City of Mississauga

City Department and Agency Comments

Date Finalized: 2025-03-13	File(s): A34.25
To: Committee of Adjustment	
From: Committee of Adjustment Coordinator	Meeting date: 3/20/2025 1:00:00 PM

Property Address: 693 Mississauga Valley Blvd

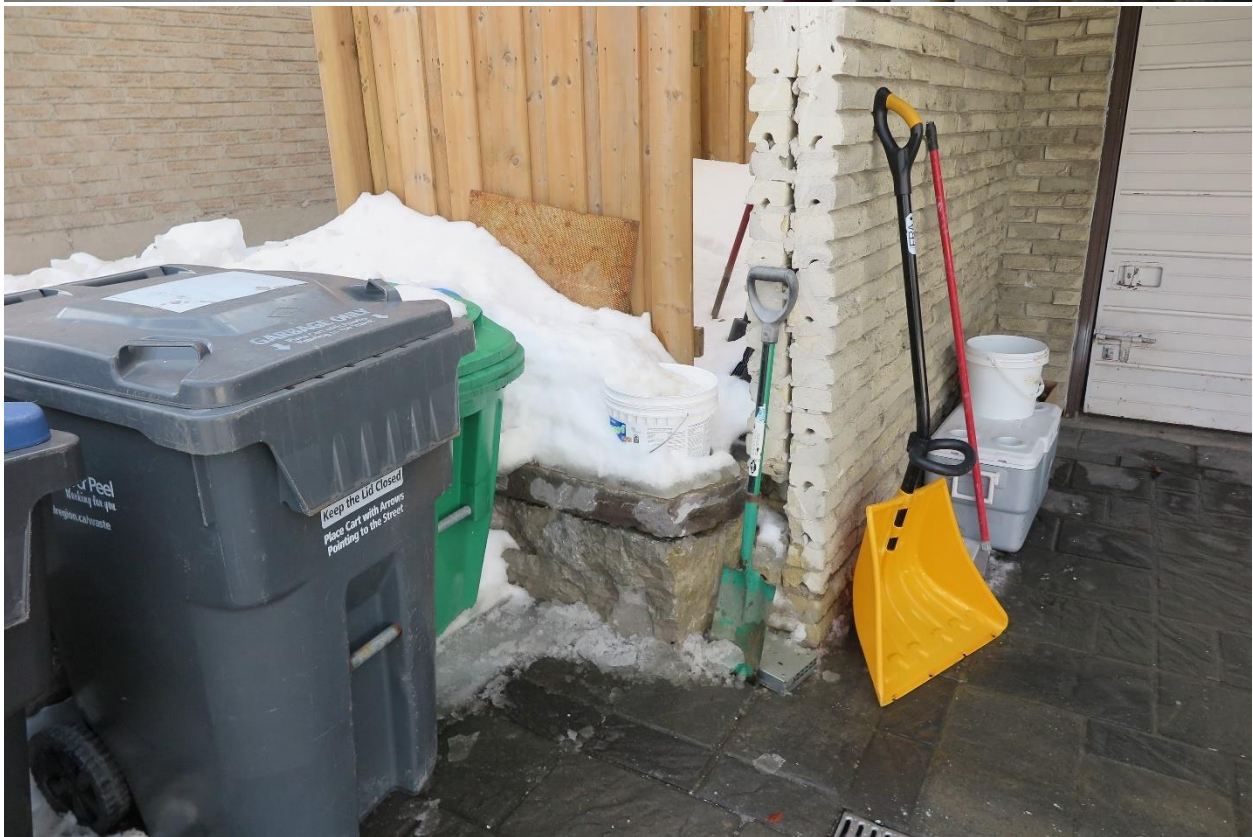
Enclosed for Committee's reference are several photos which depict the excessive hard surfaced areas that currently exist in the rear yard. This Department is concerned about the additional runoff into the municipal storm sewer system that will be caused by the additional hard surfacing where permeable landscaped areas once existed. Incremental increases across the neighbourhood and the municipality can lead to increased pressures on the City's storm sewer system. We note that lots are typically designed to retain some stormwater through infiltration into the permeable surfaces such as grass and other landscaped areas.

This Department notes from our site inspection that artificial turf was observed in the rear yard, which contradicts information provided on the submitted A0-001 – Site Plan. We recommend additional clarification is provided related to the extent of the artificial turf areas and sodded areas (if any) on the subject property. Additional information will also be required to confirm if the installed subbase material(s) for the artificial turf areas would allow for infiltration of stormwater.

We also note the rear yard drains toward the front of the dwelling, which is then directed into an existing drain associated with the reverse grade driveway. The excess runoff from the rear yard due to the additional hard surfaced areas compounded with the driveway drainage may result in drainage related concerns for the dwelling.

In view of the above, this Department has concerns with the request(s) as submitted and recommend that the applicant make efforts to reduce the amount of hard surfaced areas within the rear yard. Upon receipt of a modified proposal and re-inspection of the property without the snow cover, this Department can re-evaluate the request(s).
